Product Change Notice (PCN)

PCN Number: PCN-0450965R-01

Product(s) Affected: MJ1-2503A

Comparison plastic housing as below:

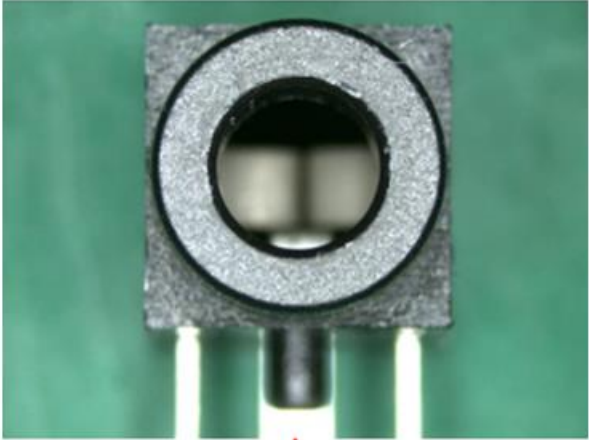
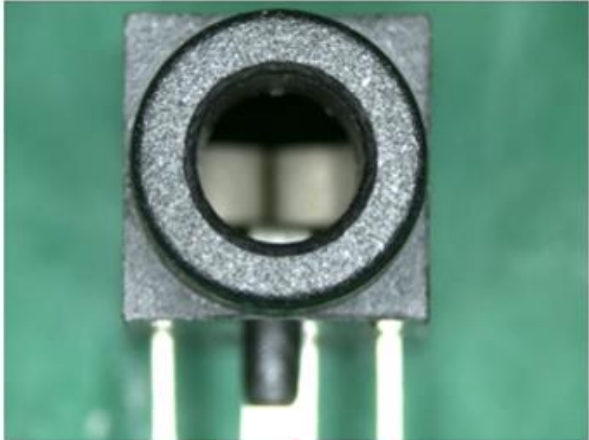
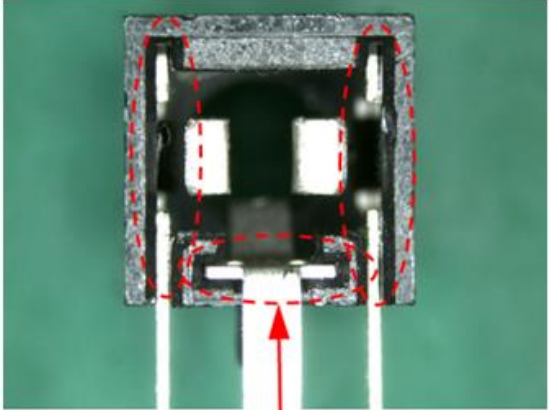
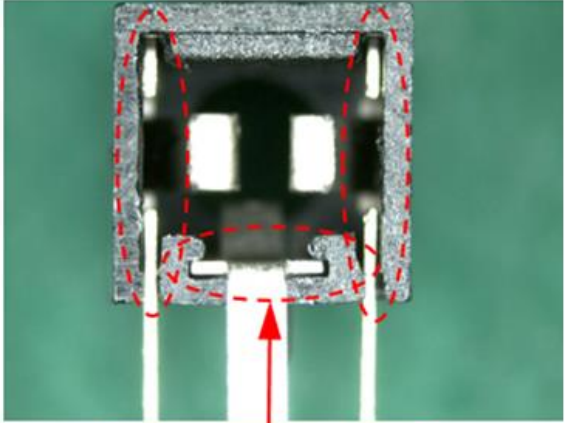
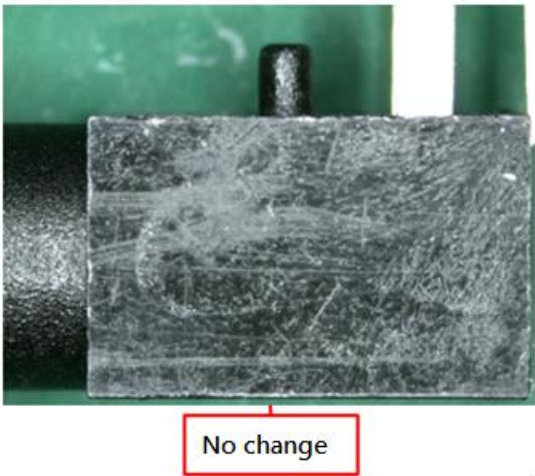
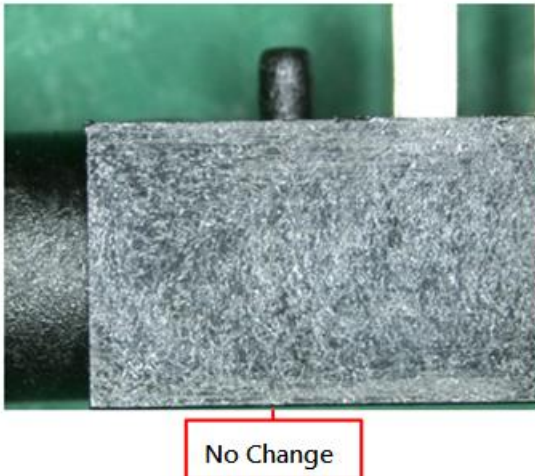
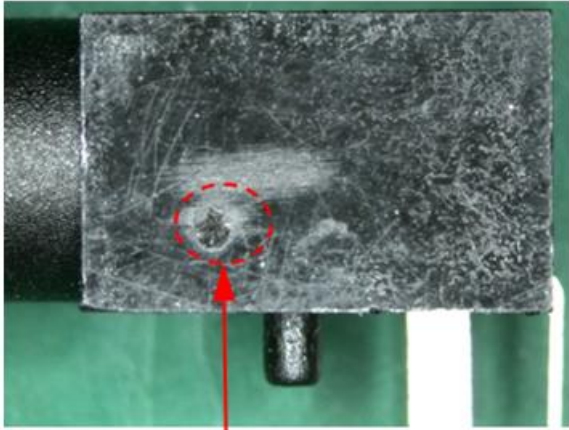
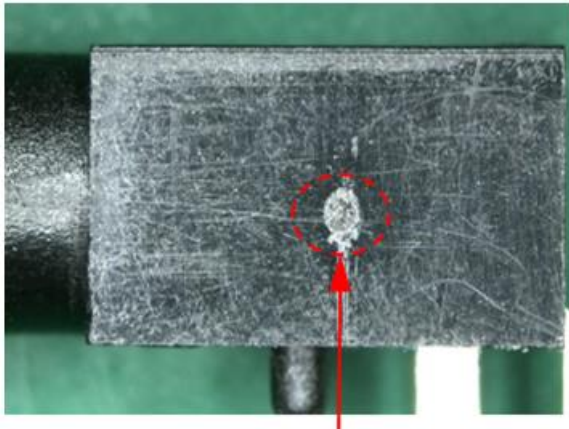
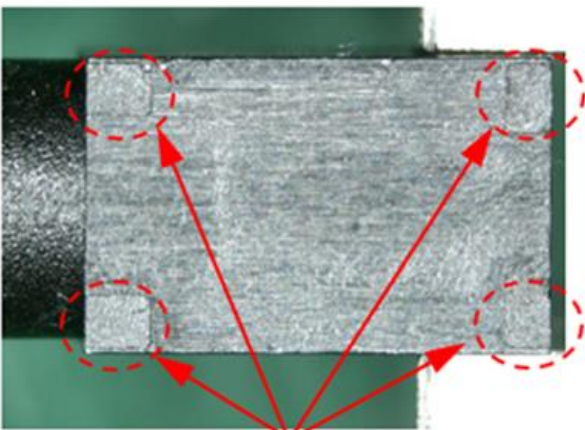
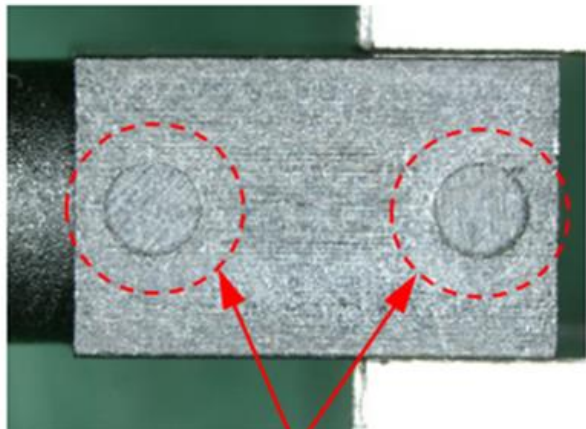
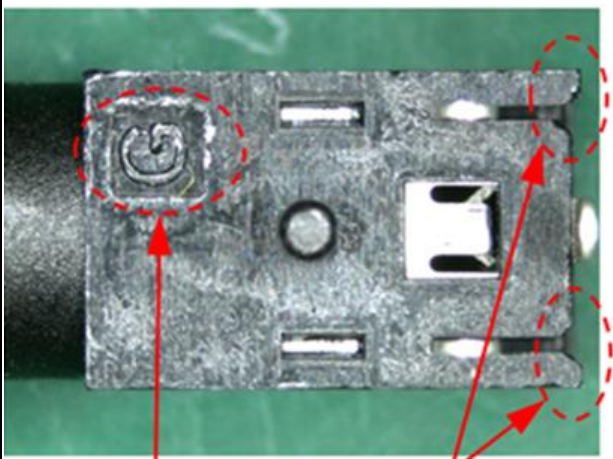
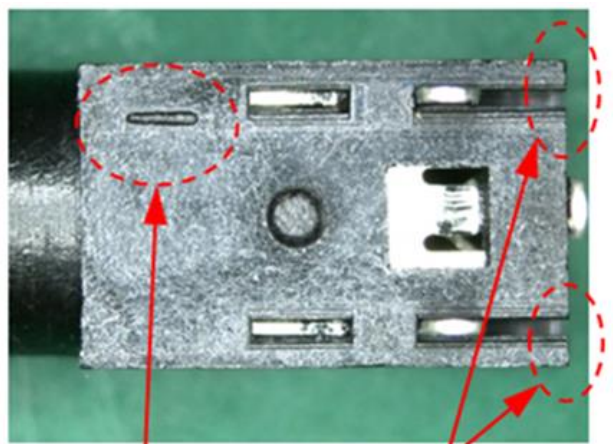
New version	Current version
Front	 <p>No change</p>	 <p>No change</p>
Back	 <p>add Chamfer</p>	 <p>No Chamfer</p>

<p>Left</p>	 <p>No change</p>	 <p>No Change</p>
<p>Right</p>	 <p>Injection point</p>	 <p>Injection point</p>
<p>Top</p>	 <p>with four square marks</p>	 <p>with two circle marks</p>

Bottom

outlook different

add chamfer

outlook different

no chamfer
